Change Notice No.	Notification date	Implementation date
CN/F/21/007	December 31, 2021	January 31, 2022

Subject : Improved design of Cartridge Filters with adapter code 'Seal-M'

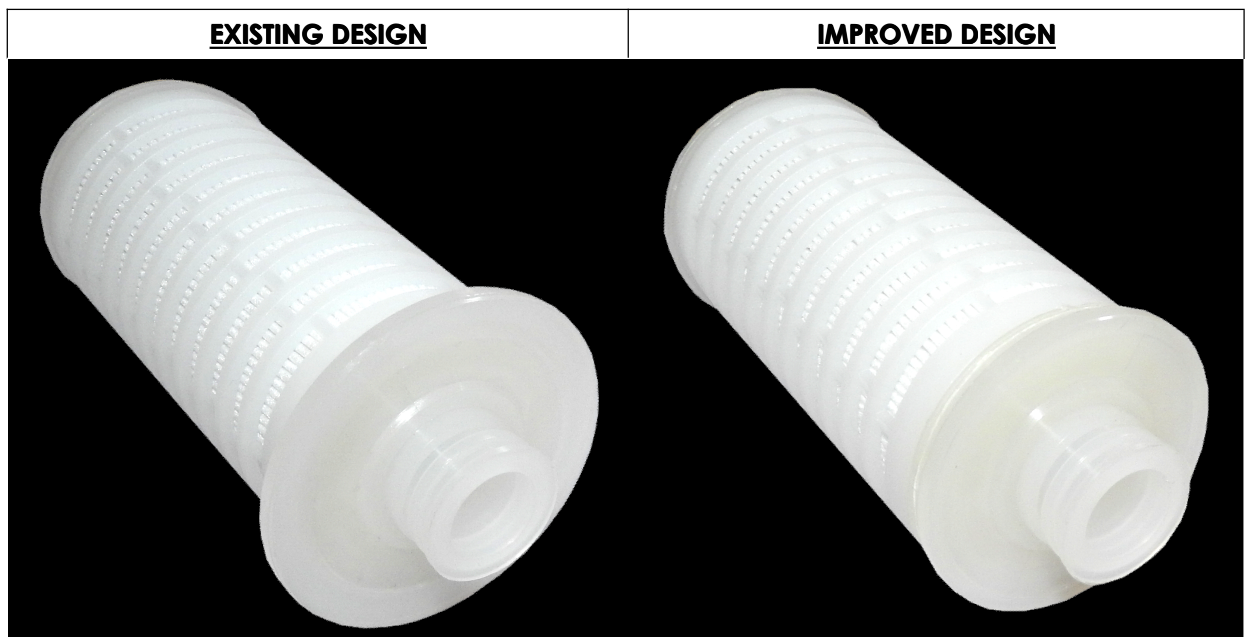
The design of **mdj** Cartridge Filters with adapter code 'Seal-M' include a collar, at bottom of the cartridge element and just above the adapter used for the fitment of cartridge filter in respective housing. It was observed that in some of the cartridge housings, the collar of the fitted cartridge filter (with adapter code 'Seal-M') hinders the flow path by covering some part of fluid inlet of the housing. To overcome this issue, the design of **mdj** Cartridge Filters with adapter code 'Seal-M' has been changed and the outer diameter of collar is reduced.

No change has been done in any other critical dimensions or materials of construction or manufacturing process of **mdj** Cartridge Filters with adapter code 'Seal-M'.

From a practical point of view the changes done in mdi Cartridge Filters with adapter code 'Seal-M' will enhance the functionality during actual use. All performance specifications and product attributes including the fitment with respective housing will remain unchanged, except the reduced diameter of collar of mdi Cartridge Filters with adapter code 'Seal-M'.
